LIST OF APPENDICES

Submission for Compliance with Approval Condition (d) - the Submission of a Revised Fire Service Installations Proposal

**Proposed Temporary Place of Recreation, Sports or Culture (Hobby Farm) for a
Period of 5 Years and Filling of Land in "Agriculture" Zone, Lots 84 S.A ss.1 (Part)
and 84 S.A RP (Part) in D.D. 112, Nam Hing West Road, Shek Kong, Yuen Long**
(Application No. A/YL-SK/299)

Submission for Compliance with Approval Condition (e)

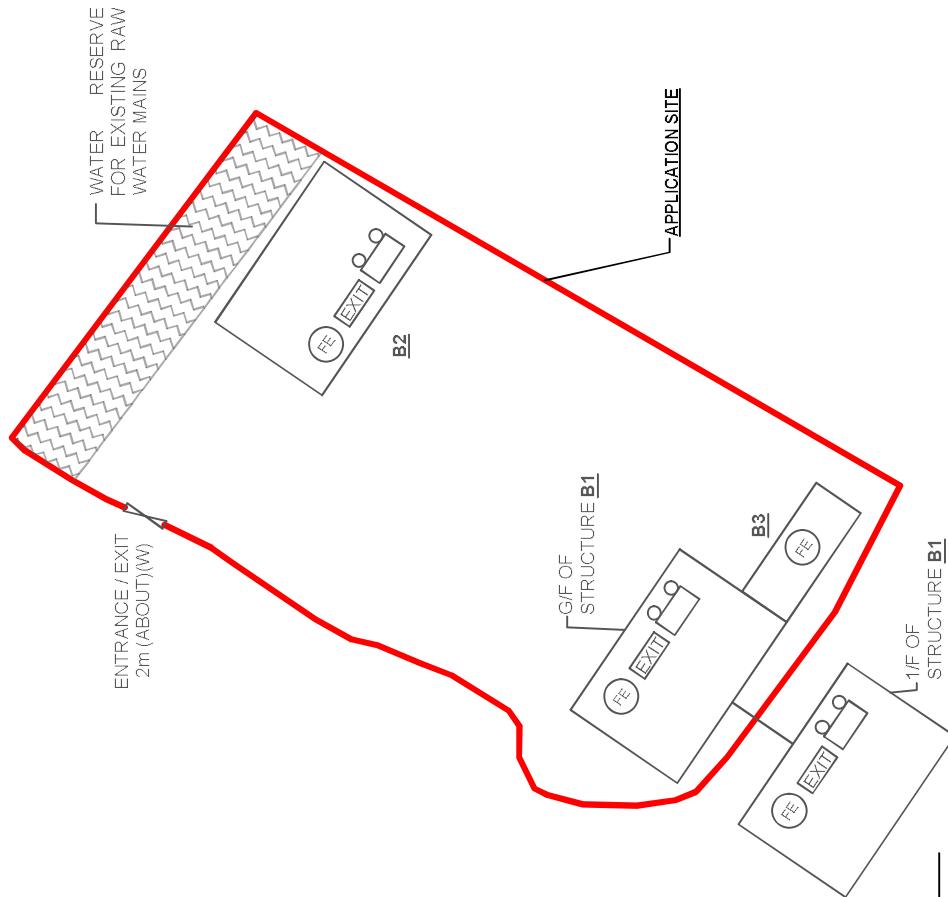
We are writing to submit a revised FSIs proposal (**Appendix I**) and a certificate of fire services installations (**Appendix II**) for compliance with approval condition (e) of the subject application, i.e. the implementation of a revised FSIs proposal. Amended detail as follow:

- 1) Transitioned to 4 nos. of 5KG CO2 fire extinguisher for improved effectiveness.

FIRE SERVICE INSTALLATIONS	
3 x EXIT SIGN	
3 x EMERGENCY LIGHTING	
4 x 5 KG CO2-TYPE FIRE EXTINGUISHER

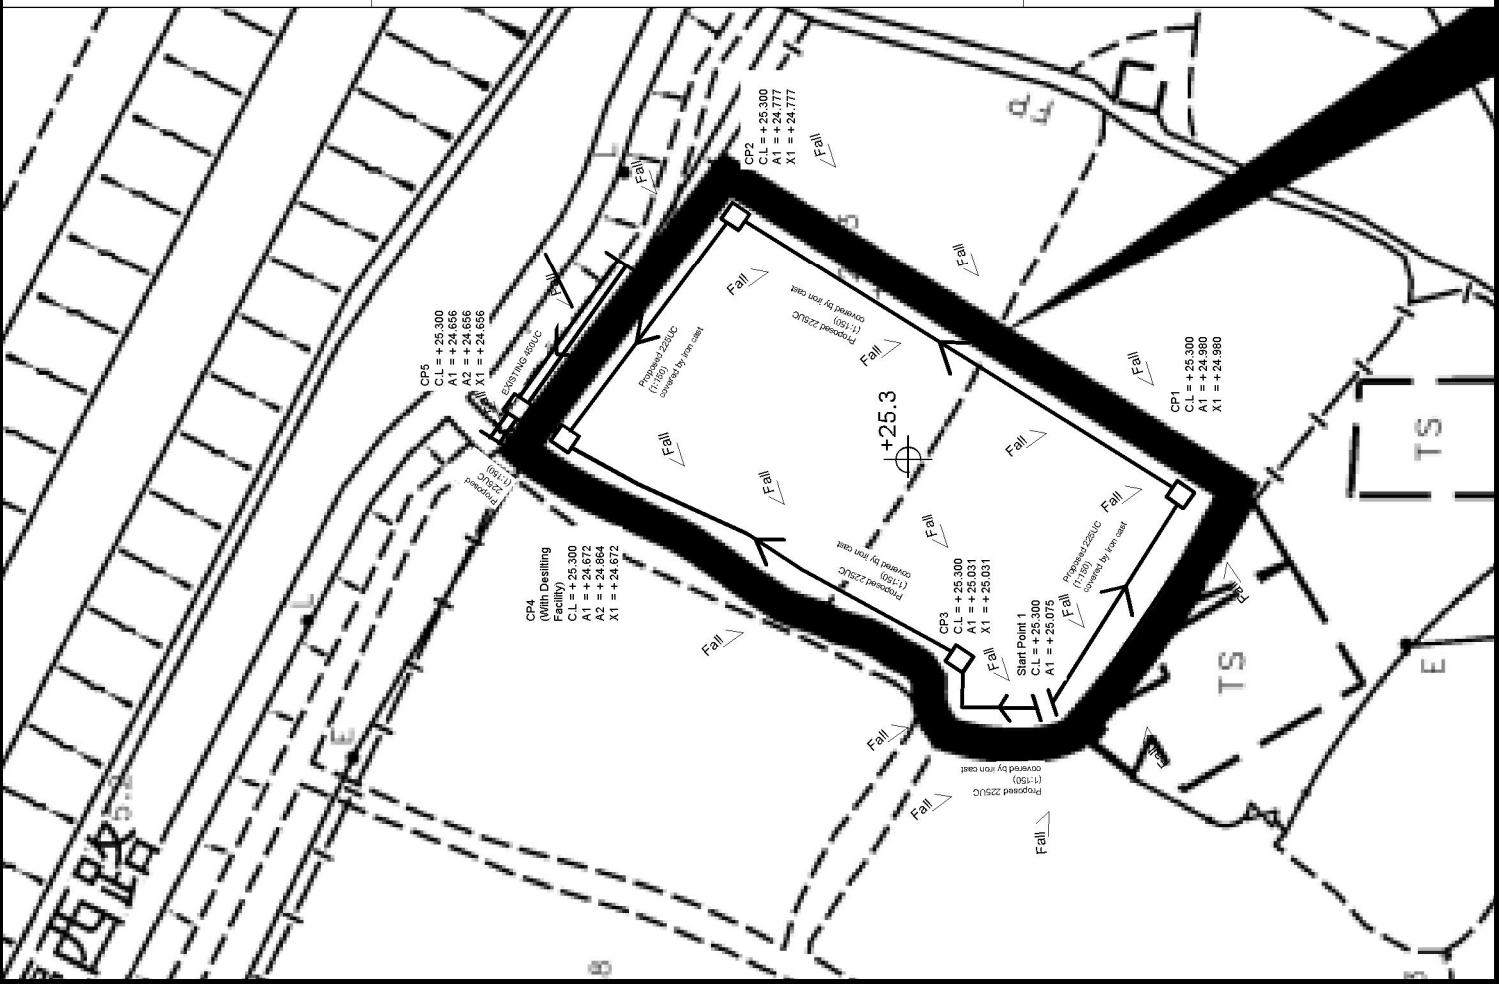
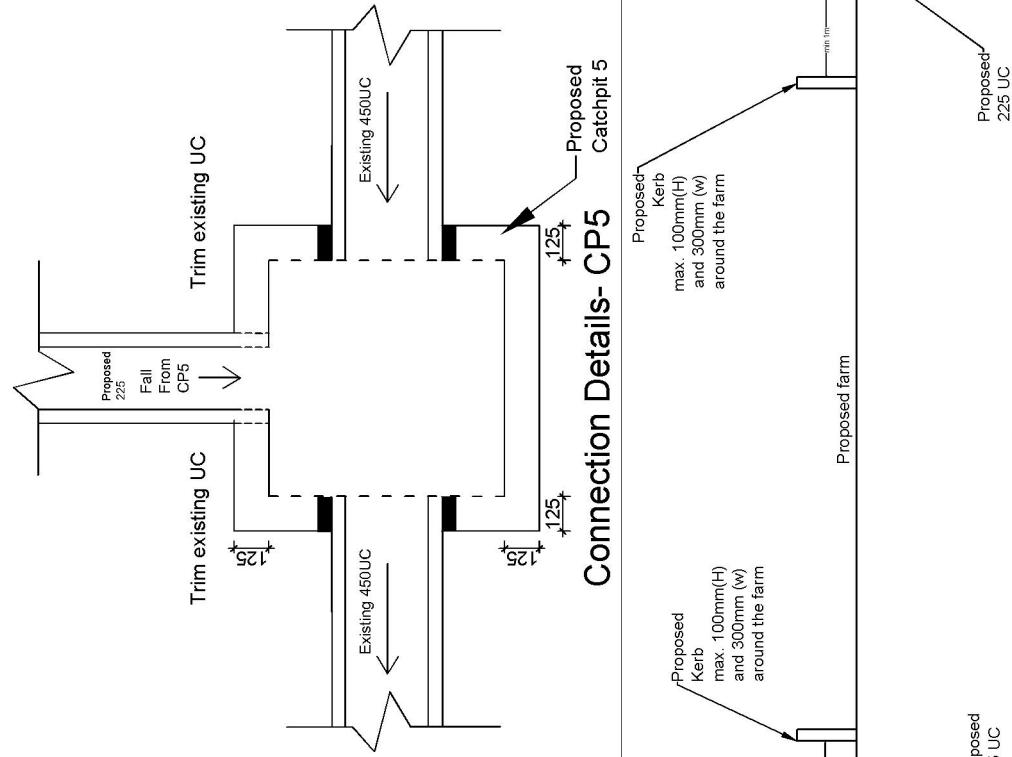
Comments from the CE/MN, DSD:

- (i) The applicant should provide a material submission of the flap valve and agree with this office before installation.
- (ii) The applicant should implement the drainage facilities on site in accordance with the agreed drainage proposal. Please inform this office before commencement of the drainage works.

- (iii) The applicant is required to rectify the drainage system if they are found to be inadequate or ineffective during operation. The applicant shall also be liable for and shall indemnify claims and demands arising out of damage or nuisance caused by a failure of the drainage system.

- (iv) The proposed development would neither obstruct overland flow nor adversely affected any existing natural streams, village drains, ditches and the adjacent areas.

- (v) The applicant should consult DLO/YL and seek consent from relevant lot owners for any works to be carried out outside his lot boundary before commencement of the drainage works.

a) Accepted drainage proposal layout

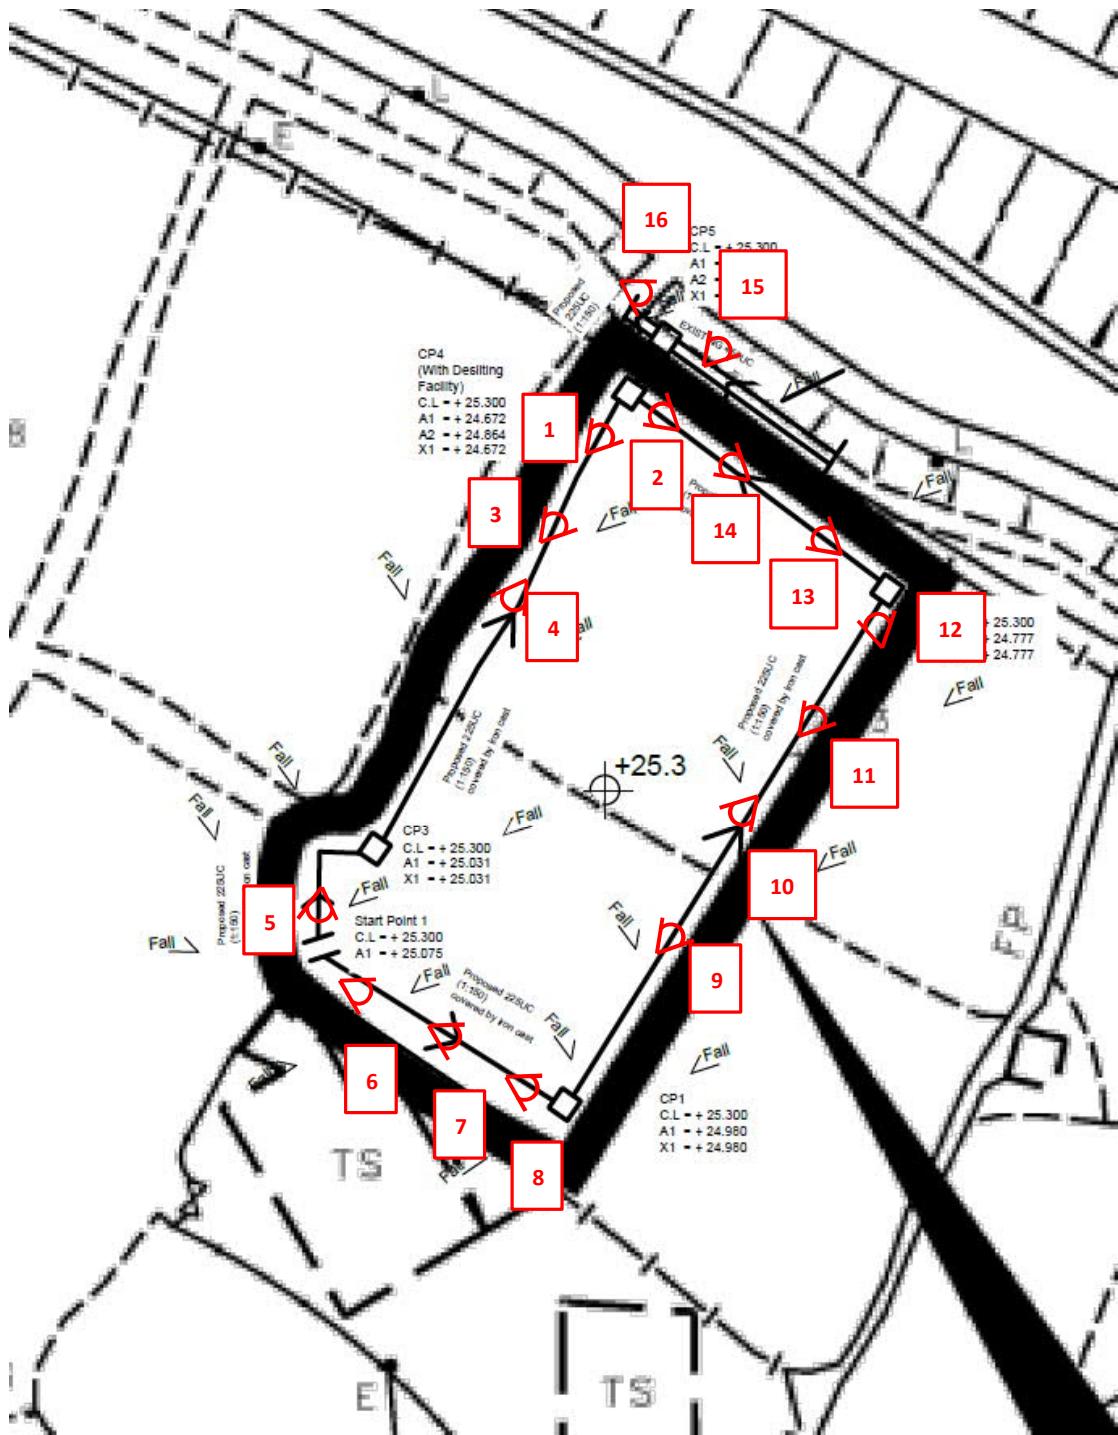
Comments of the Director of Drainage Services:

- The applicant is advised to maintain all the drainage facilities on site in good condition and ensure that the proposed development would neither obstruct overland flow nor adversely affect existing natural streams, village drains, ditches and the adjacent areas, etc. The applicant is required to rectify the drainage system at their own expense to the satisfaction of government parties concerned if they are found to be inadequate or ineffective during operation.
